Addendum 02 for RFB937600-01

Project Name: CC Parking Lot 15 Replacement
DAS RFB #: 937600-01
DAS Project #: 9376.00
Date: 4/18/2024

Reference for location and depth of tunnel beneath Lot #15

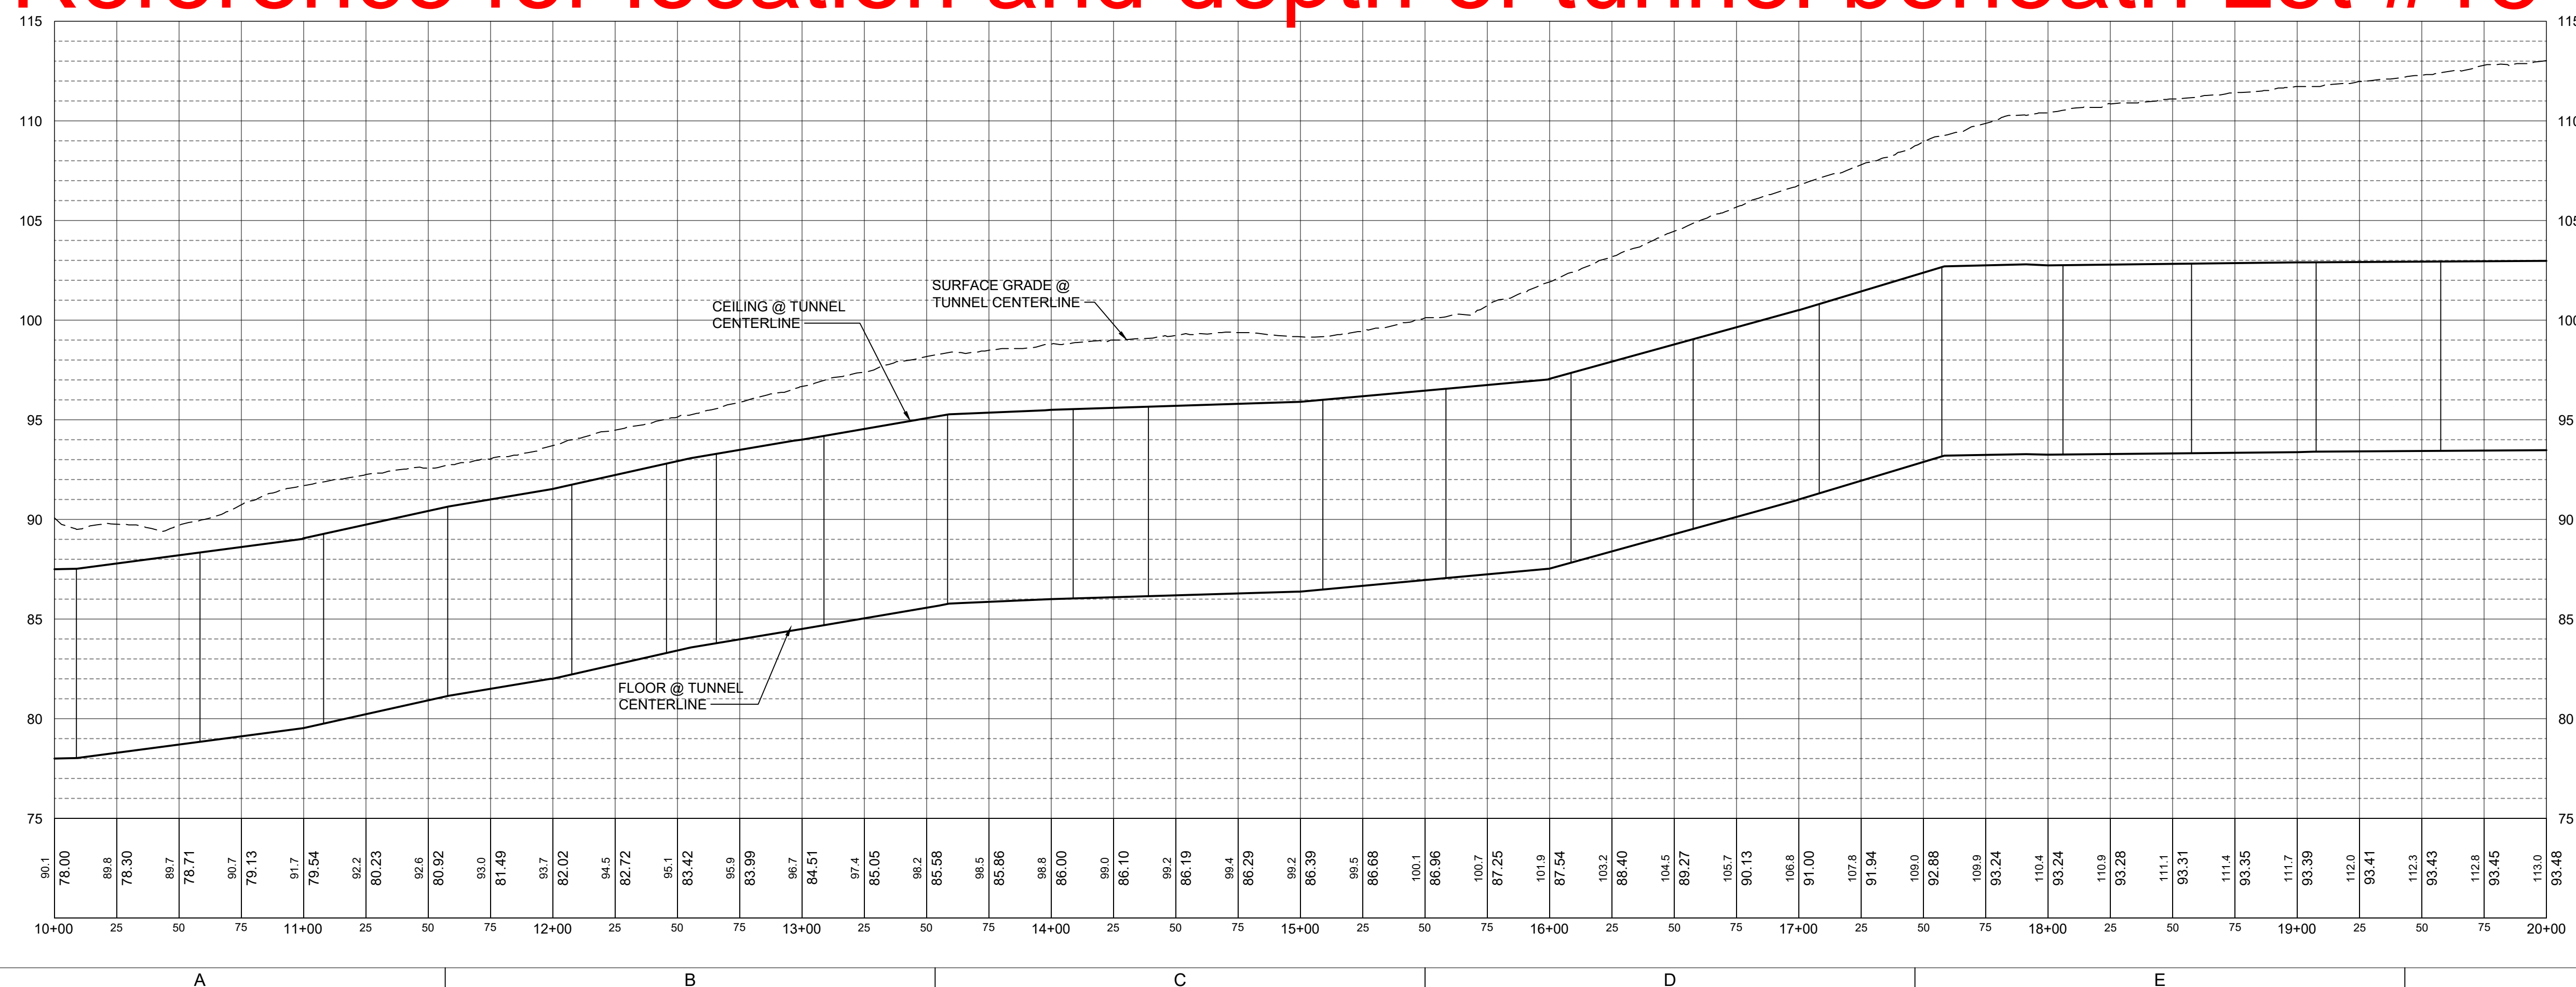
Q: Is there a drawing showing the location of the tunnel and tunnel depth? I just want to make sure it is identified for grading contractor to determine what equipment will be allowed in this area.

A: Please see sheet C102 at the end of in this addendum from the DAS Tunnel Joint Repair Project that shows the depth of the tunnel.
